Hatton Solar Farm Correction of drawing Errors in relation to the red line boundary.

1. East side boundary adjustment (update on left, old on right)

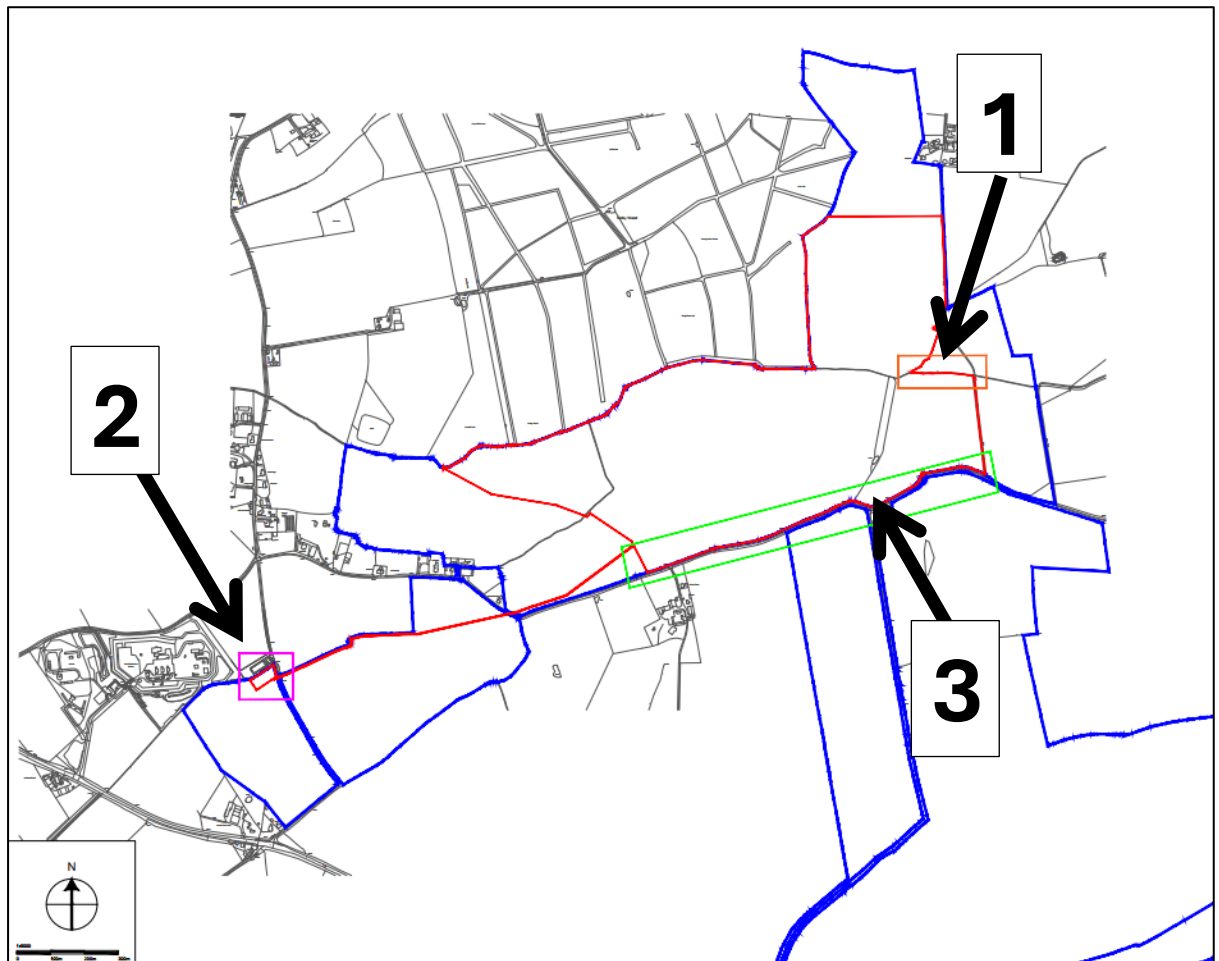
The eastern boundary has been revised to align with the existing field boundary rather than following a straight line across Parcel 4. This amendment ensures a more accurate representation of the land division.

2. DNO Substation boundary adjustment (Update on left, old on right)

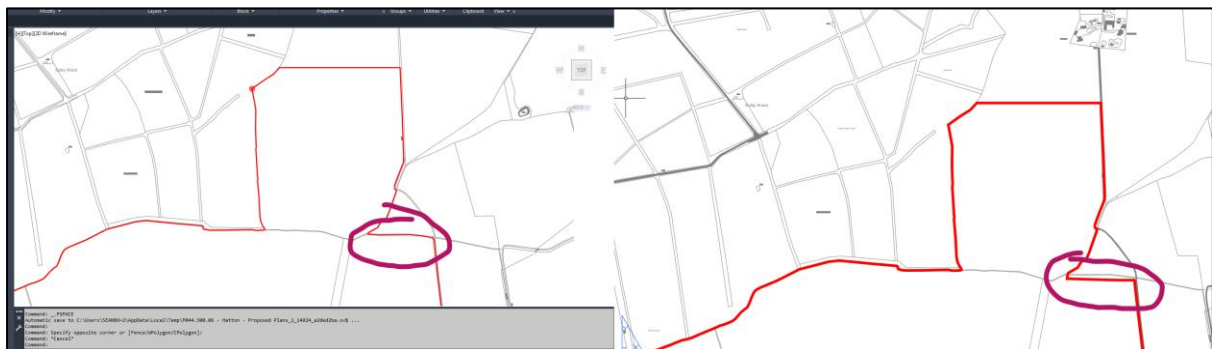
The boundary around the Point of Connection (POC) has been modified to fall entirely within the landownership boundary. Previously, certain sections extended beyond the ownership limits, necessitating this correction.

3. Southern boundary adjustment (update on left old on right)

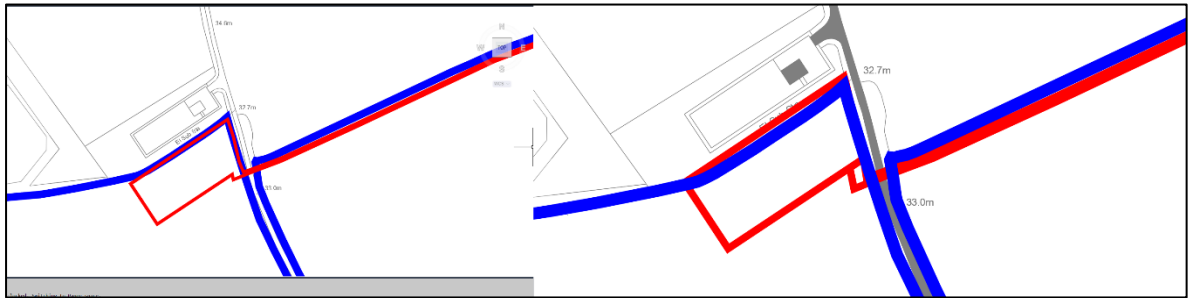
The southern boundary has been refined to accurately follow the landownership limits. The previous alignment left some equipment and access points outside the lease area, which has now been rectified to ensure all infrastructure remains within the designated leasehold.
